ARCHITECTURAL REVISIONS - SHEET NOTES

PUD REVISIONS

2229 M STREET NE

ZONING COMMISSION
District of Columbia
CASE NO. Z-2024-0011
EXHIBIT NO. 2C3

A3.13R

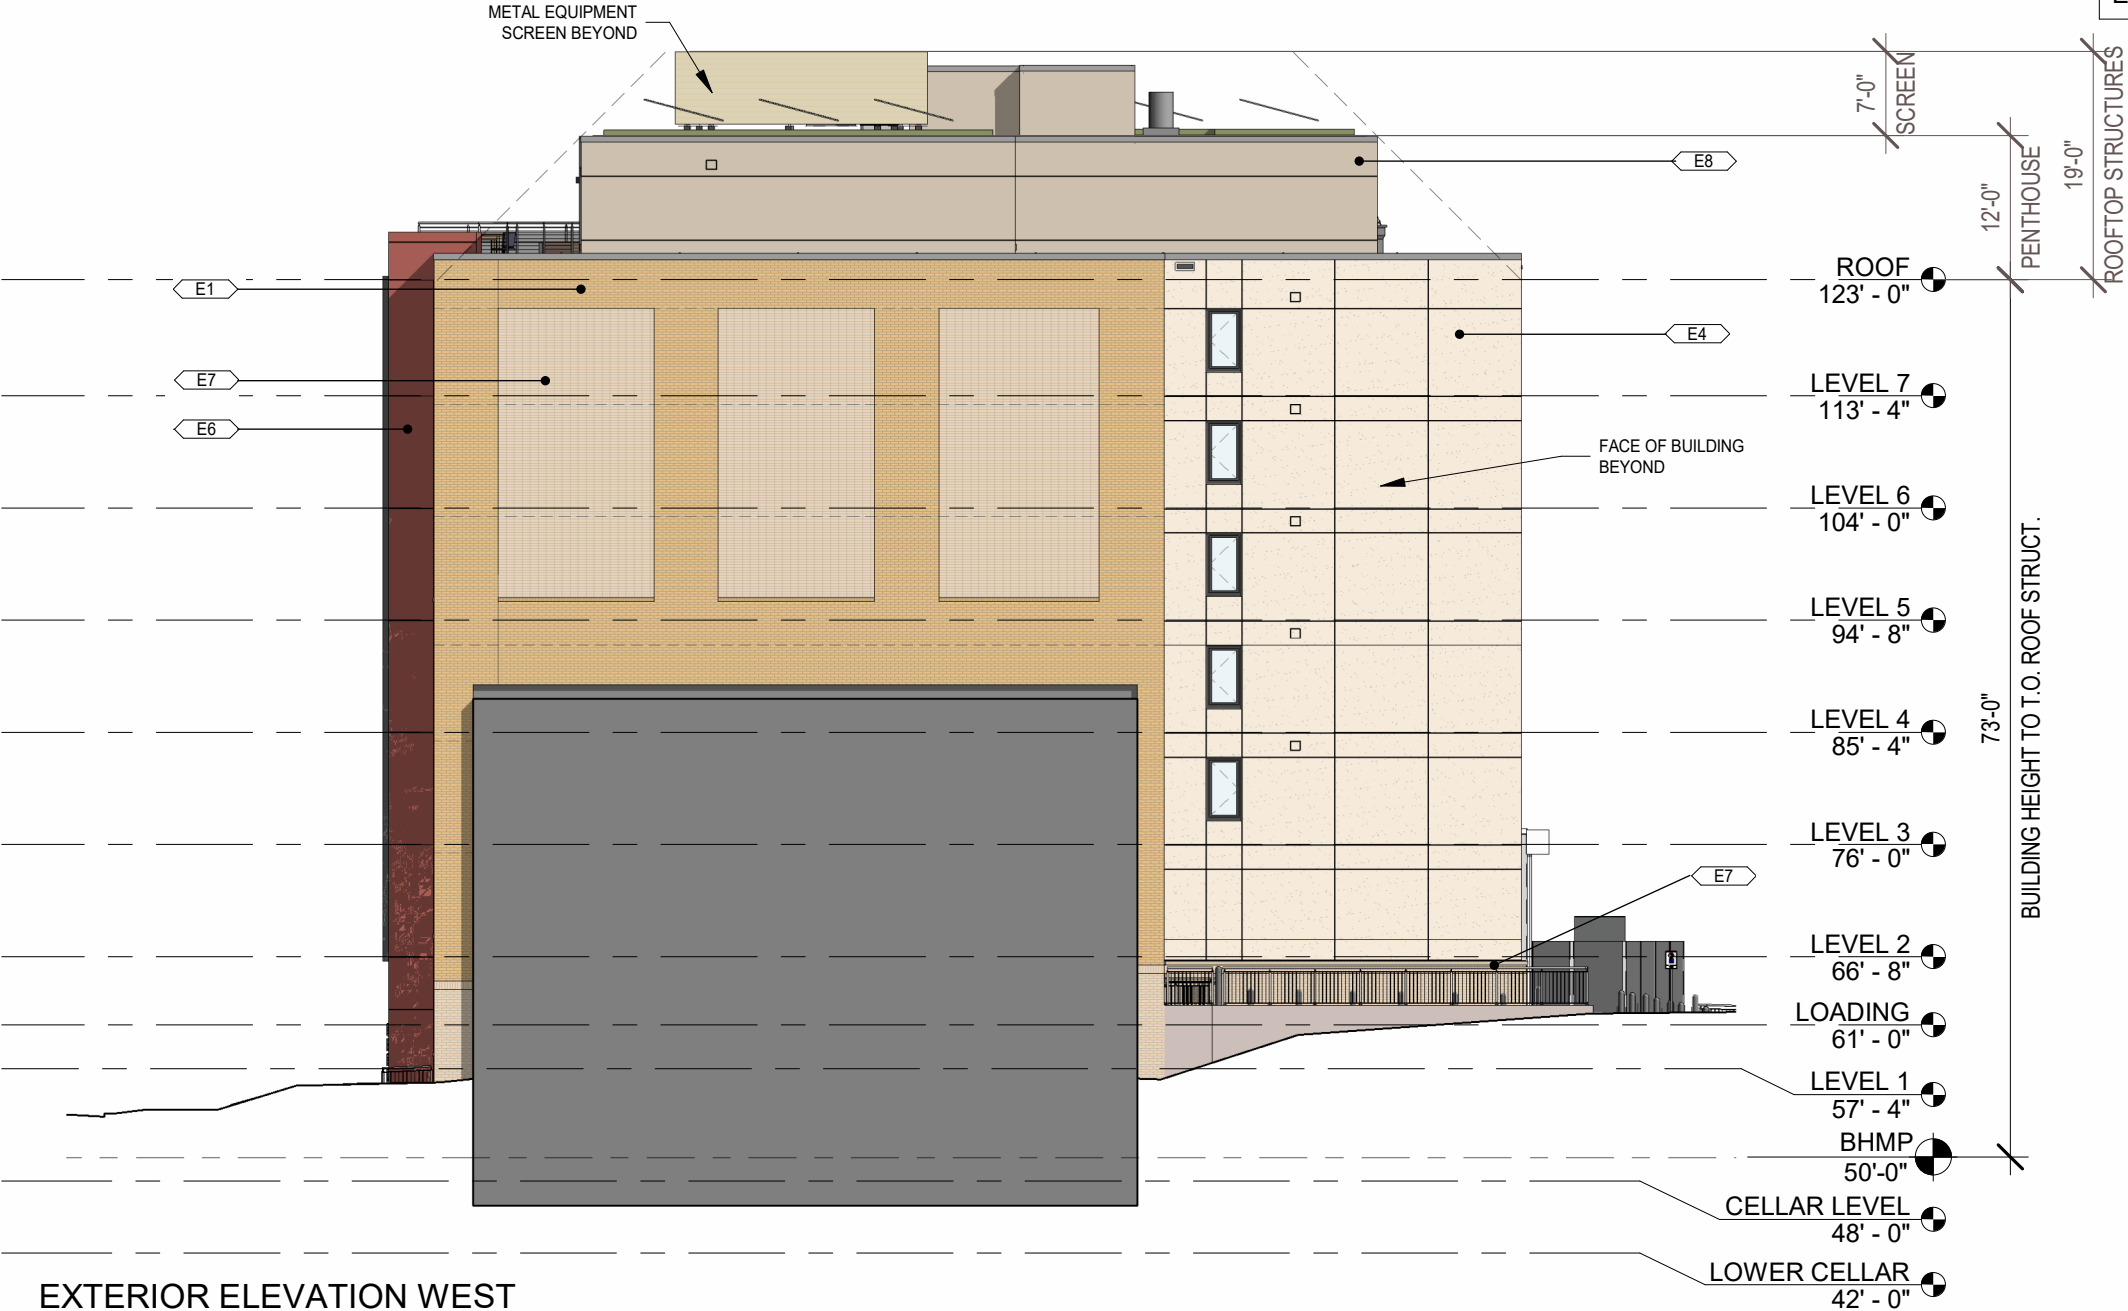
- 1. All Juliet balconies removed.
- 2. Entry terrace size reduced.
- 3. Roof terrace entrance canopy removed.
- 4. Stucco changed to EIFS.
- 5. Window sizes reduced to comply with building code max % and improve interior unit layout.
